# Public Input Appendix

**Mount Rushmore Road Corridor Study  
Public Comments Summary**

MOUNT RUSHMORE ROAD CORRIDOR DEVELOPMENT PLAN

**MT. RUSHMORE ROAD/  
8TH STREET  
CORRIDOR STUDY**

727 South Street, Circa 1888

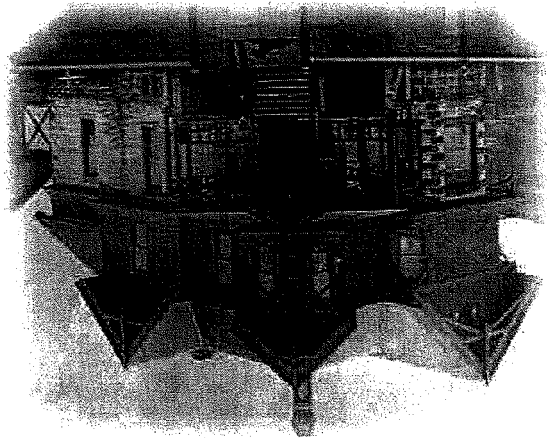
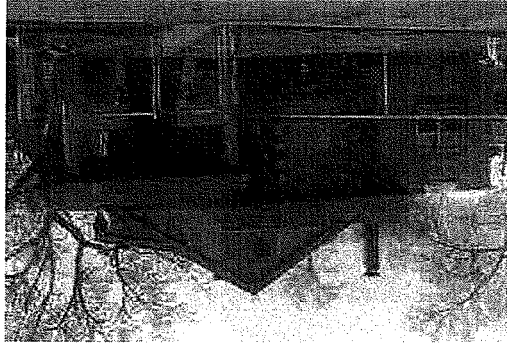
I would like to ask that the MPO include in its discussion some consideration for the historic home of Dr. Valentine McGillicuddy, on the southeast corner of Mount Rushmore Road and South Street. The house, marking its 120<sup>th</sup> anniversary this year, was recently featured in an article in South Dakota Magazine. It is one of the oldest structures remaining in town.

I believe that the McGillicuddy House, which is listed on the National Register of Historic Places, could serve as a focal point in the effort to revitalize Mount Rushmore Road. Several books have been written about McGillicuddy's adventures, many of his personal belongings are in the collection of the Journey Museum, and his ashes are entombed at the summit of Harney Peak. The McGillicuddy House is a point of interest that could attract visitors, and projects related to the restoration and preservation of the house may be eligible for grants.

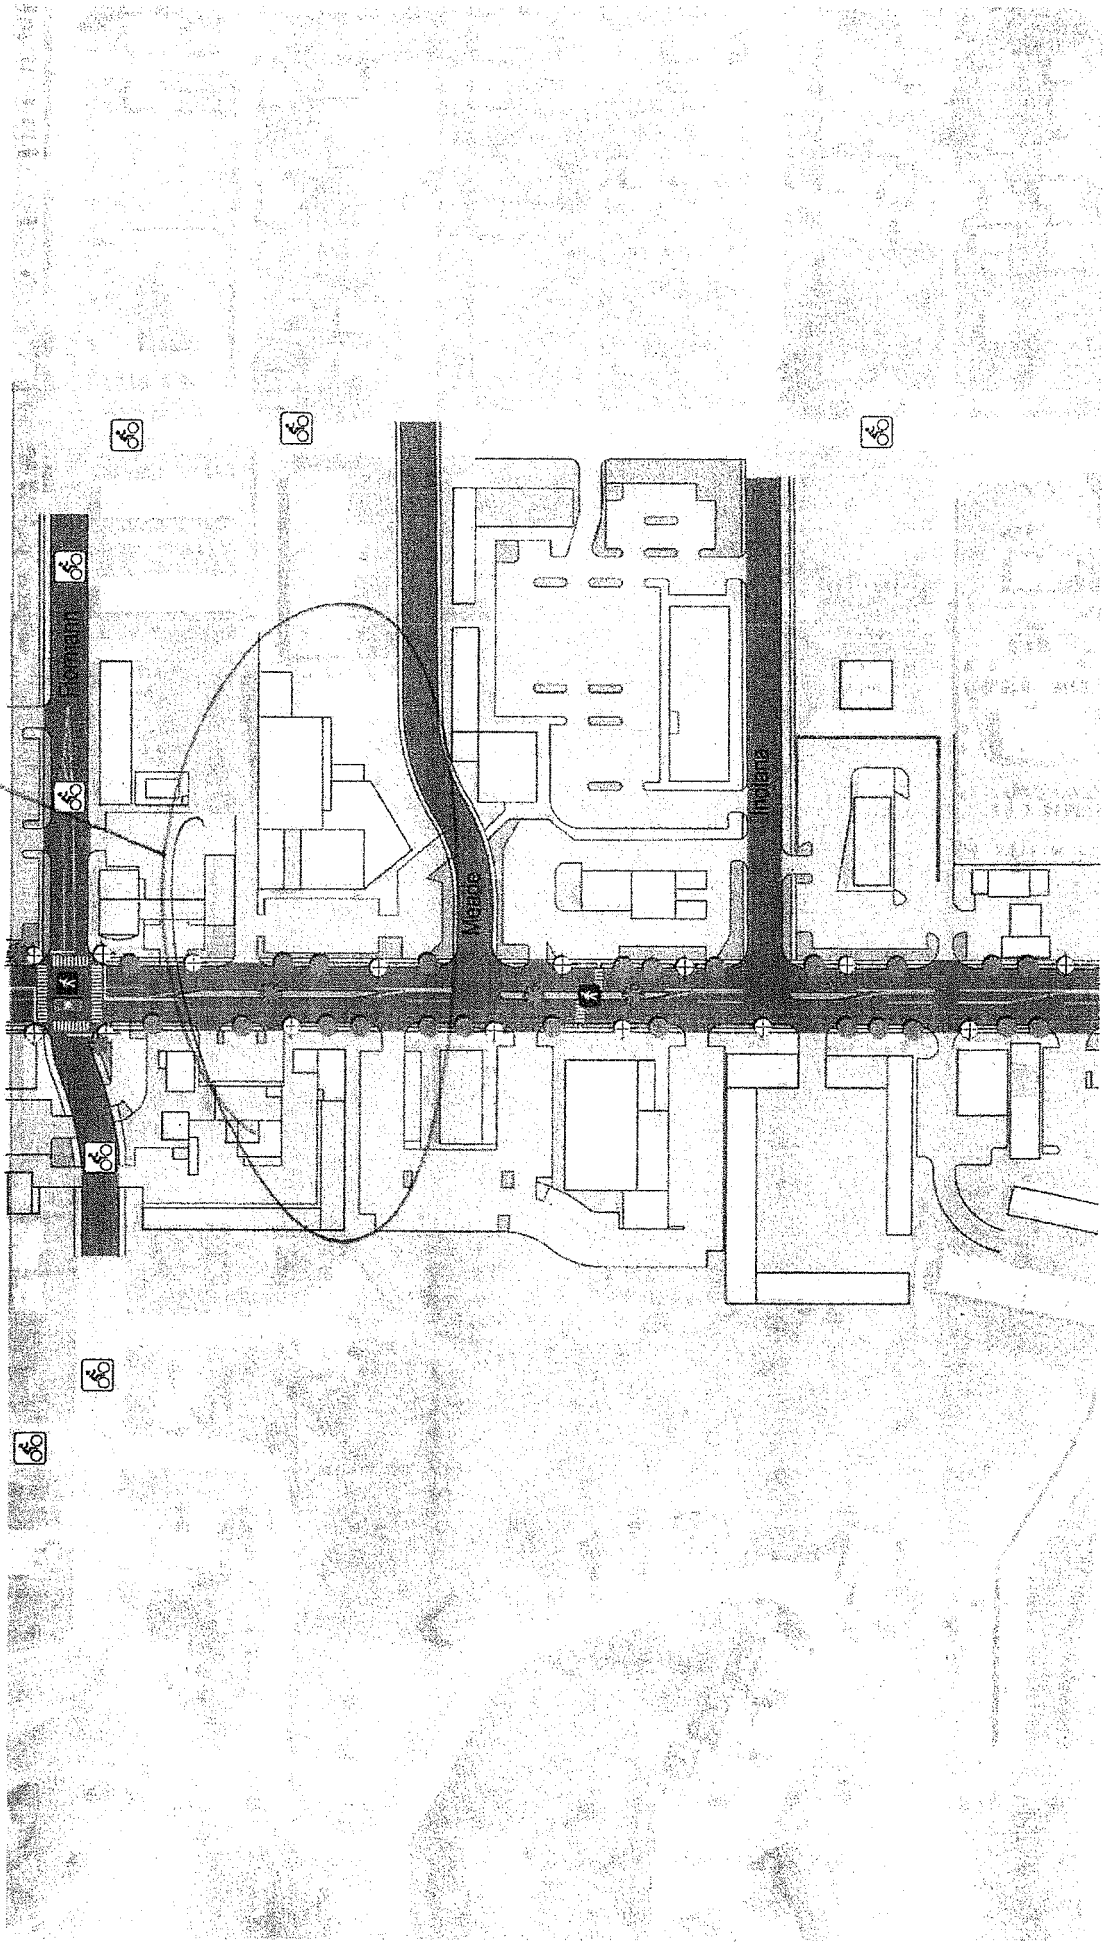
On March 20, 2006, the Rapid City Council approved a direct legal access to my property off of Mt. Rushmore Rd. This legal access is in addition to the two legal accesses to the property from Meade Street on the south side of the property and the legal access from the service alley along the north of the property. The Mt. Rushmore Rd. access was granted via a specific vote by the City Council. Furthermore, a full legal access was approved, not a mere right-in, right-out access. This full legal access requires that south-bound Mt. Rushmore Road traffic be able to utilize the access.

Therefore, please consider this letter a formal request to revise the Mt. Rushmore Road Central Corridor Analysis depiction to reflect the legal access granted by the City Council and a south-bound left turn lane to the access as shown on Attachment B to this letter.
